PRP Comments
16.06.23
Drawing Review 02

Note: These comments are solely in the capacity of Passivhaus Designer, with no design responsibility.

Ashley Road Depot

Roof Details - SMJ Flat Roof

1 | Typical External Wall/GF Slab Edge

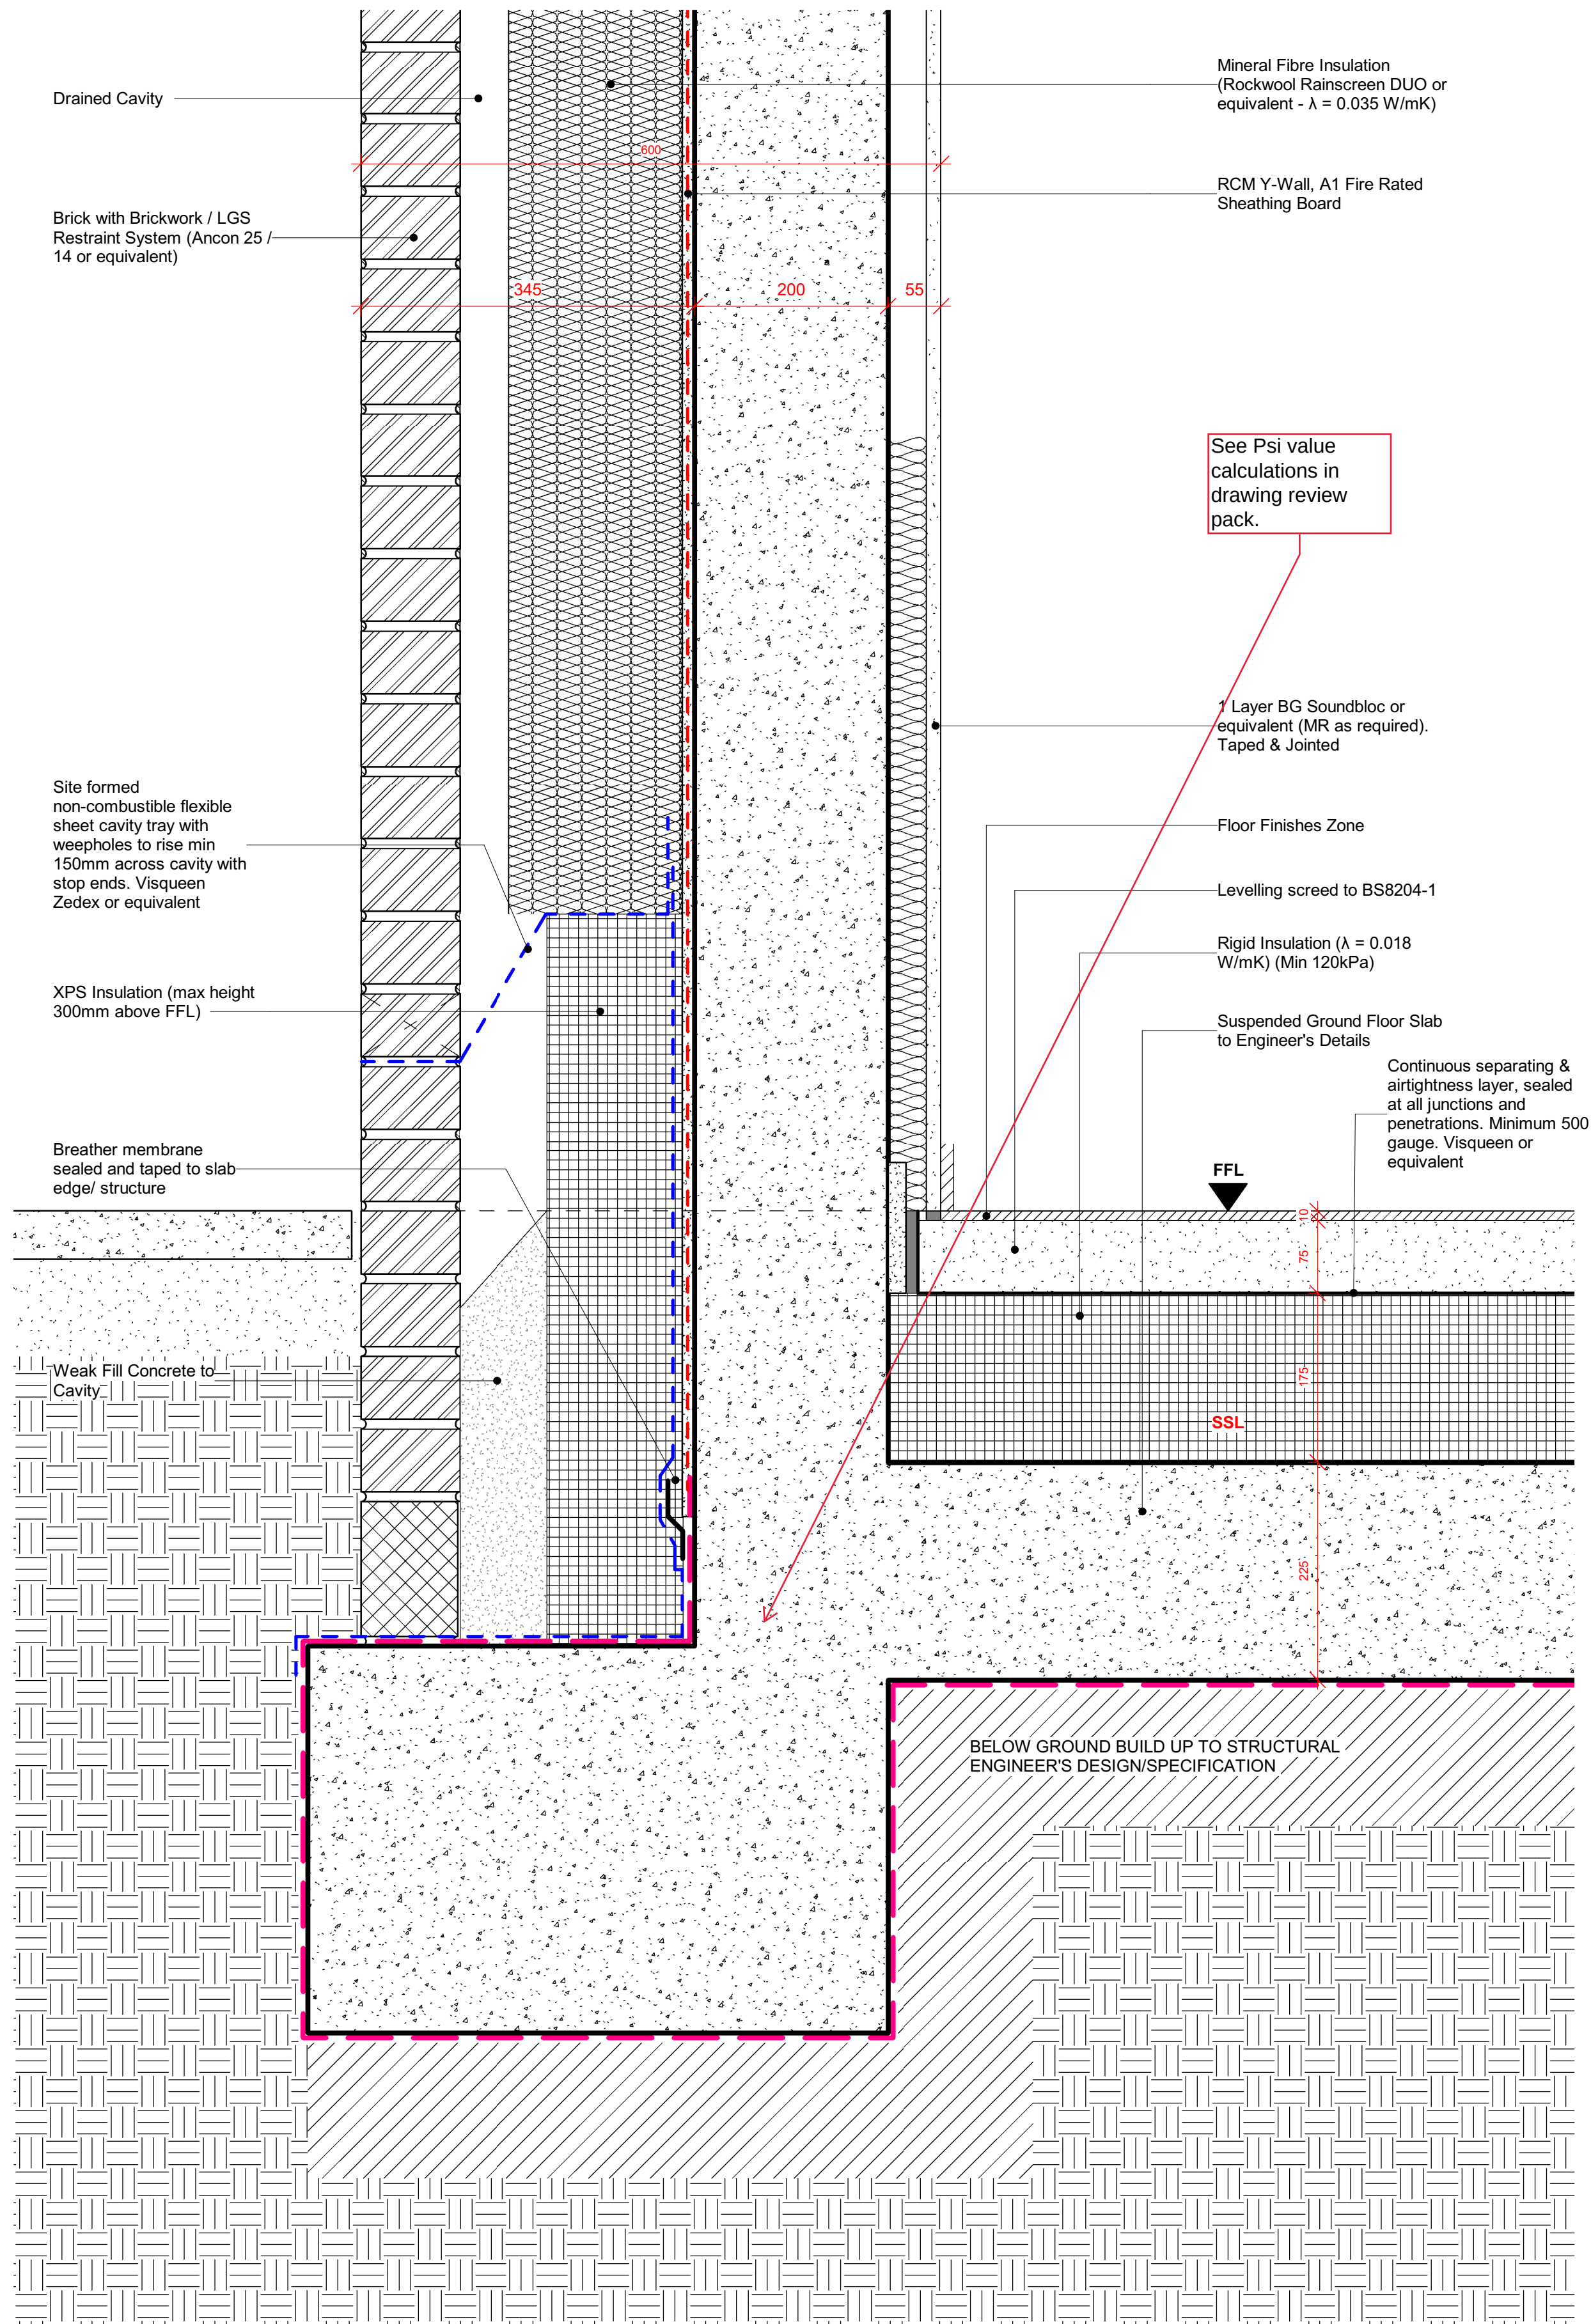
See Psi value calculations in drawing review pack.

2 | Sawtooth Brickwork Parapet Detail Plan
1 : 5

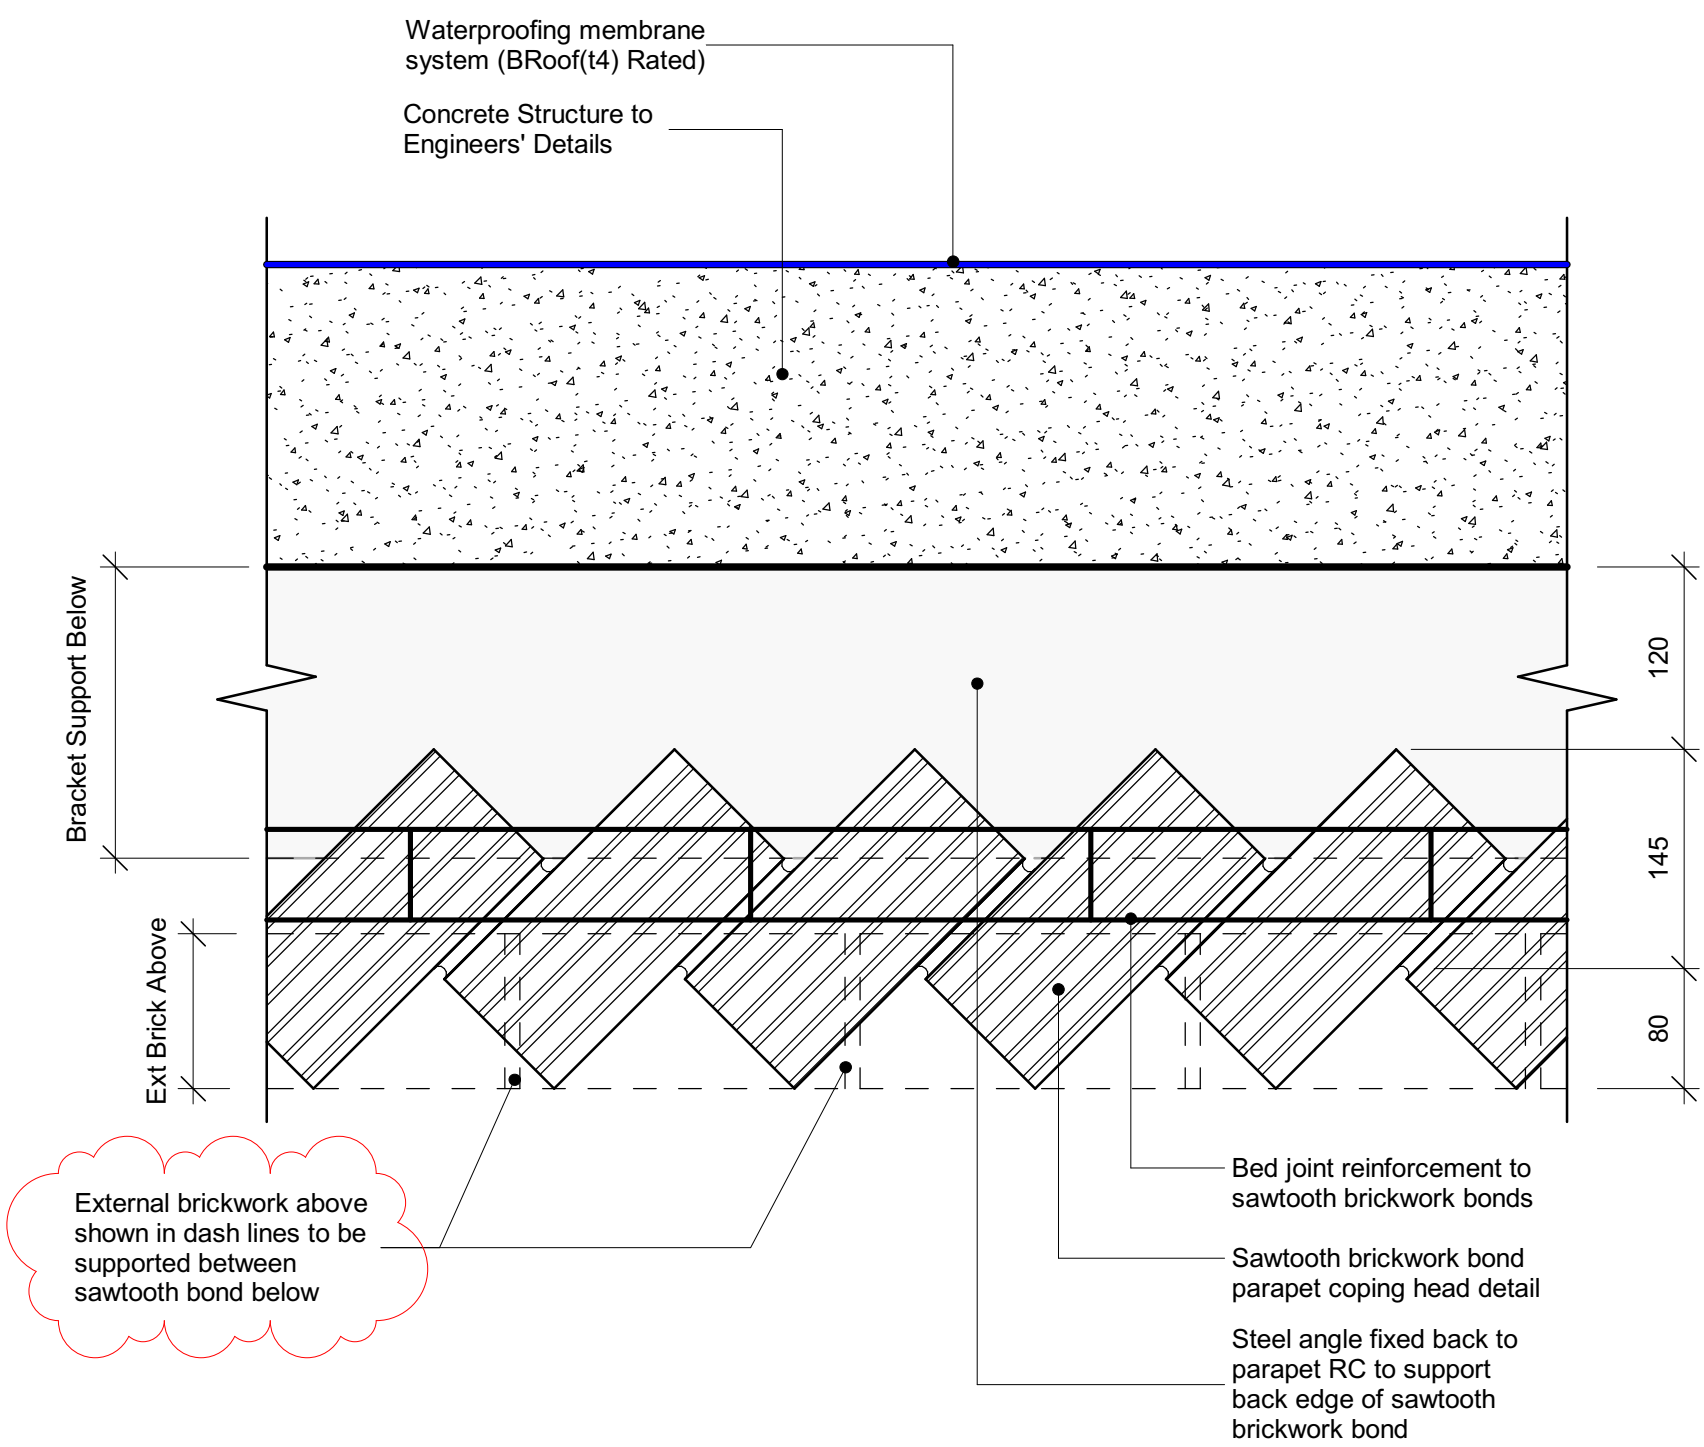
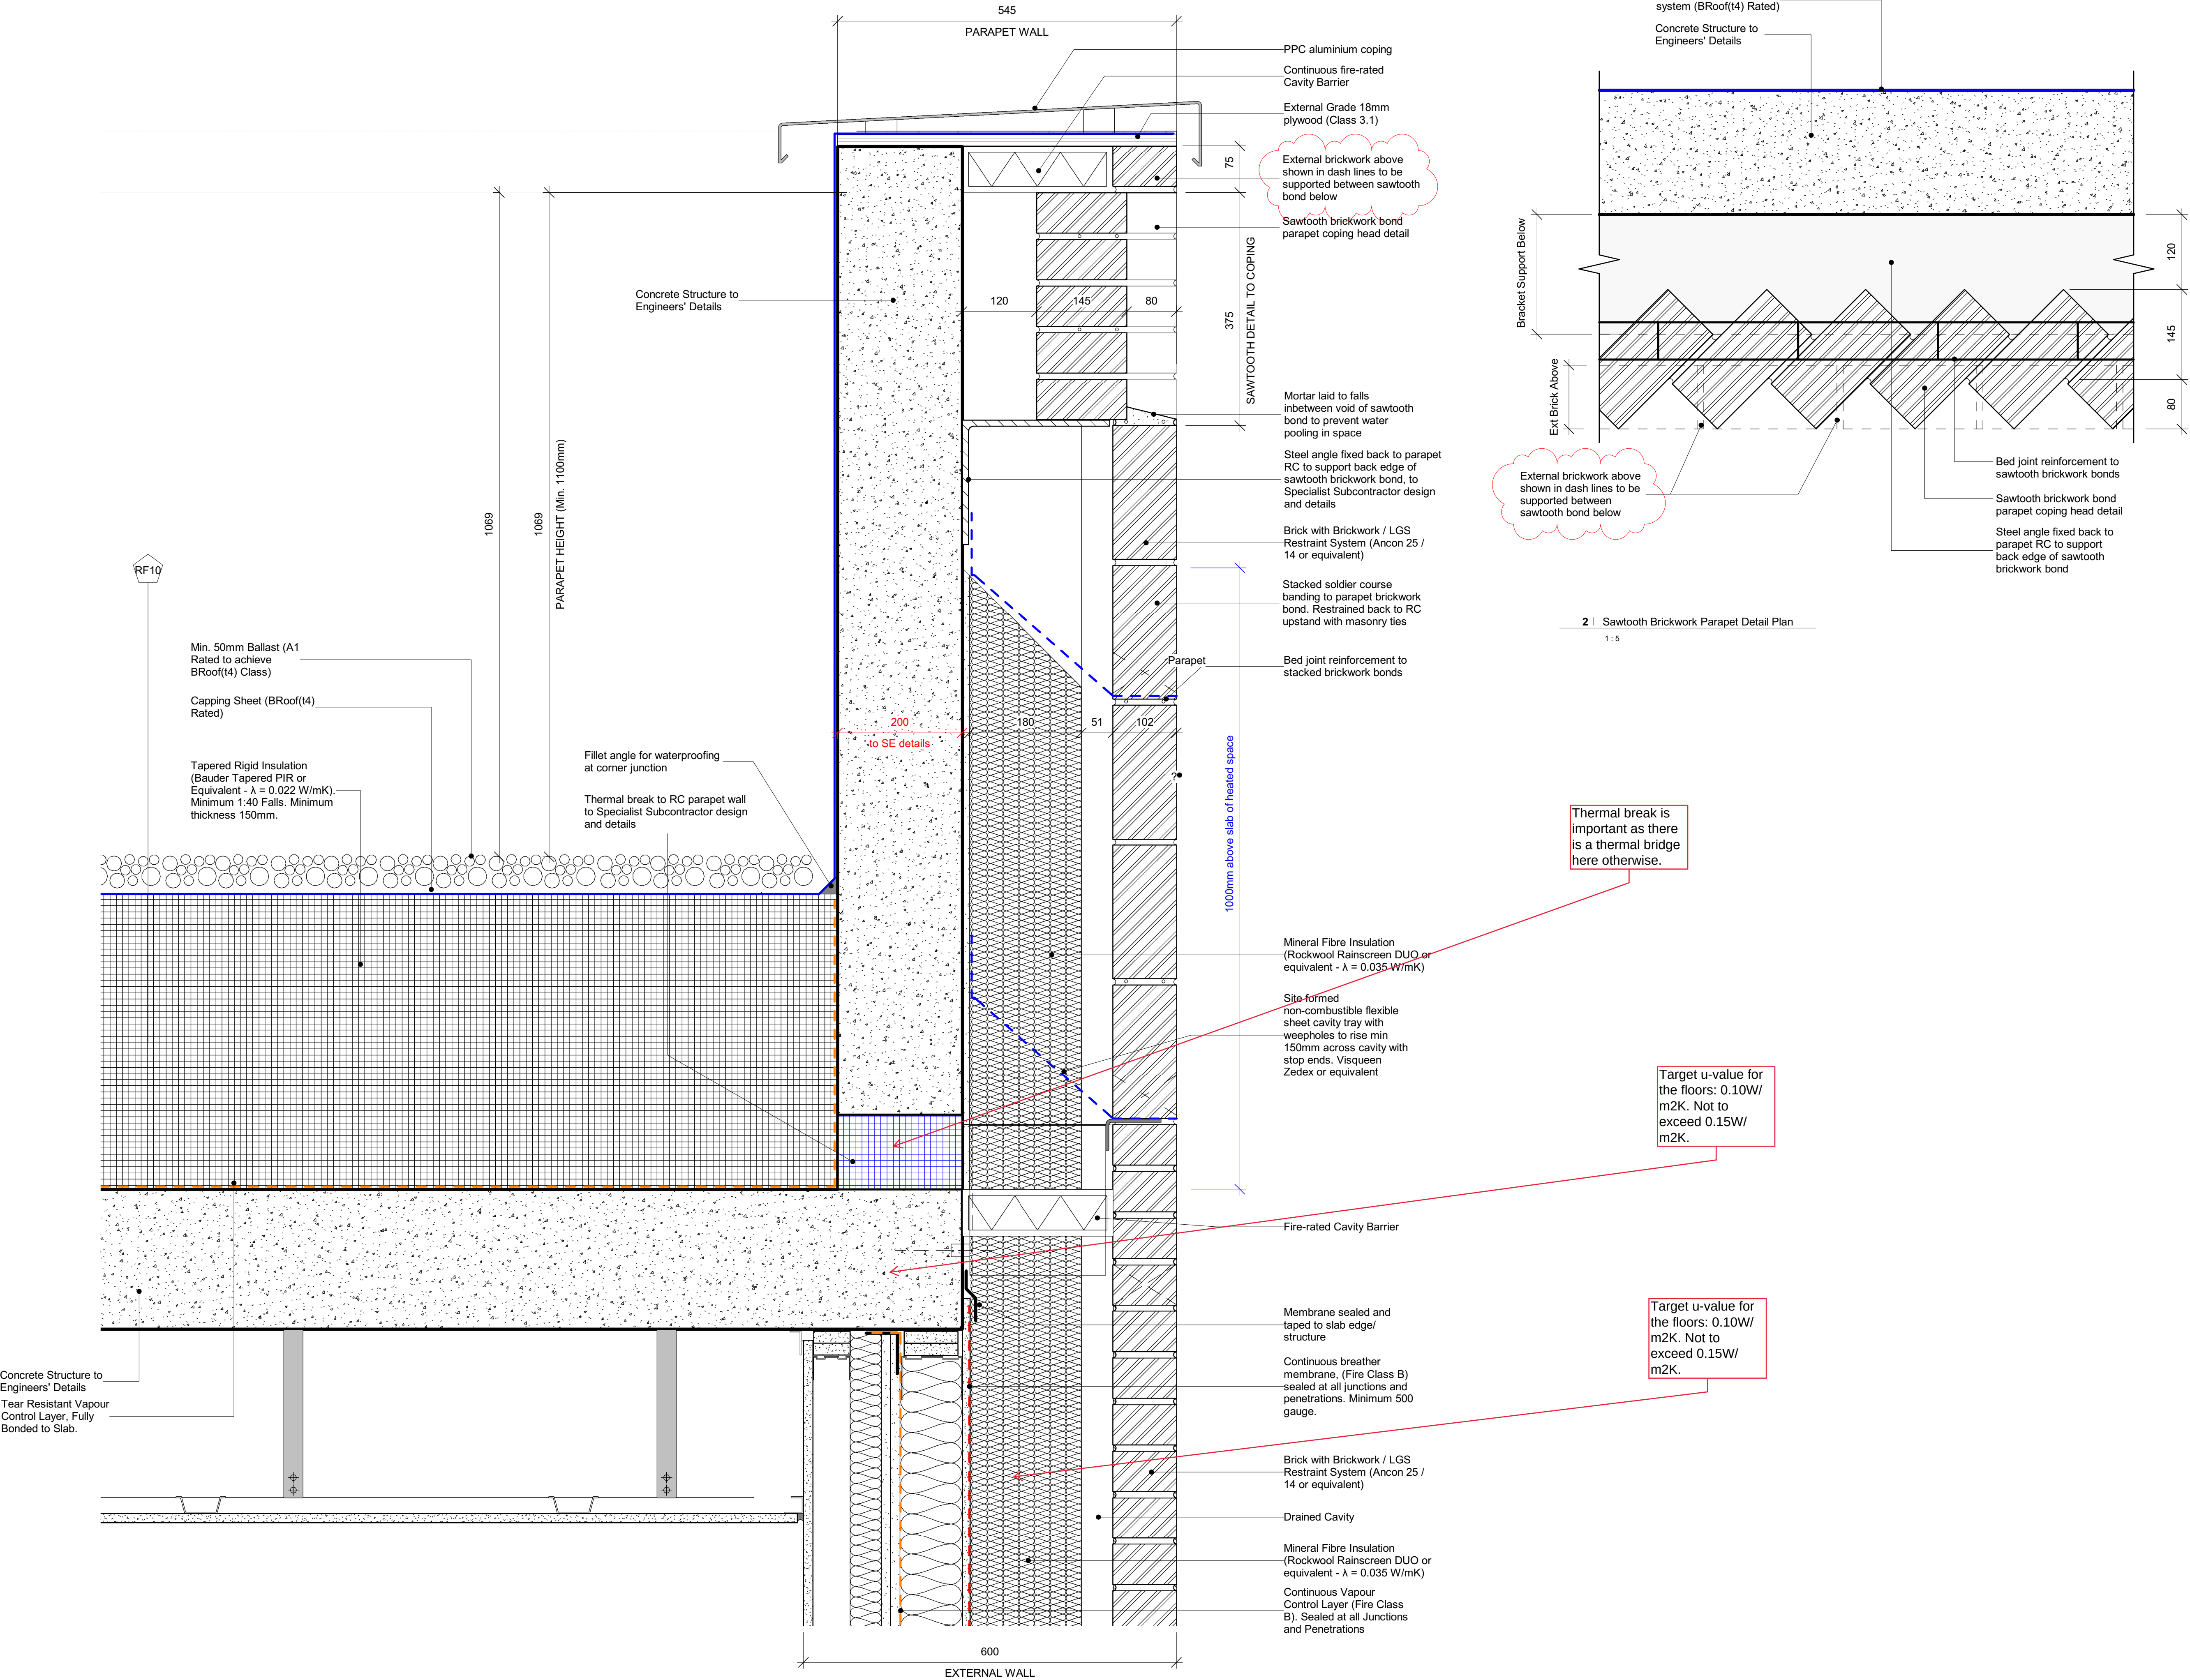
Thermal break is important as there is a thermal bridge here otherwise.

Target u-value for the floors: 0.10W/m2K. Not to exceed 0.15W/m2K.

Target u-value for the floors: 0.10W/m2K. Not to exceed 0.15W/m2K.
